Product Change Notice (PCN)

PCN Number: **PCN-0455007R**

Product(s) Affected: *PJ-036AH-SMT-TR*

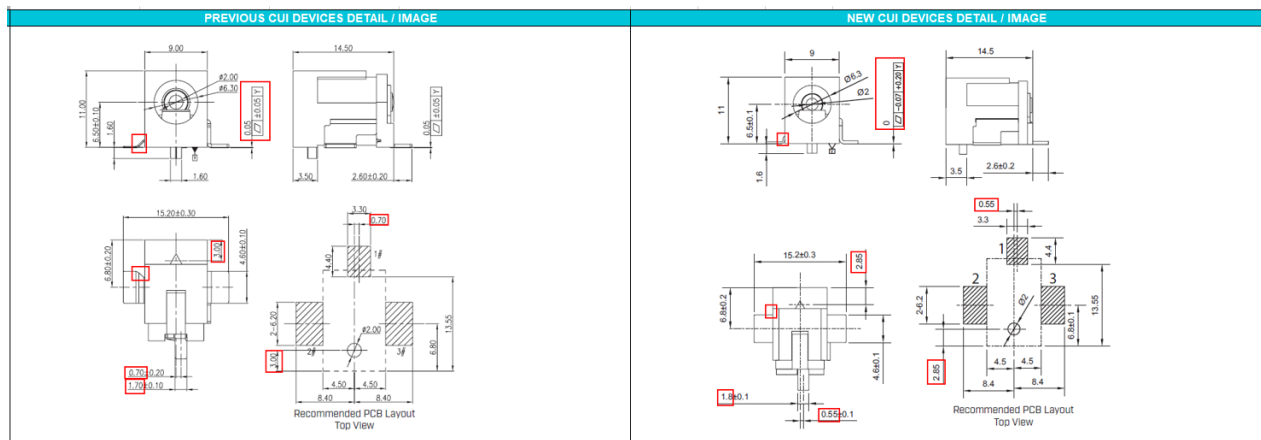
Description of Change: *Product re-engineered for improved manufacturability and production yield. Coplanarity specifications changed. Shape of terminal 2 changed. Location and size of terminal 1 changed. Locating post PCB hole location changed. See image below for reference and check CUI Devices website for updated drawing. Cosmetic differences may be visible and not affect the form fit and function of the product.*
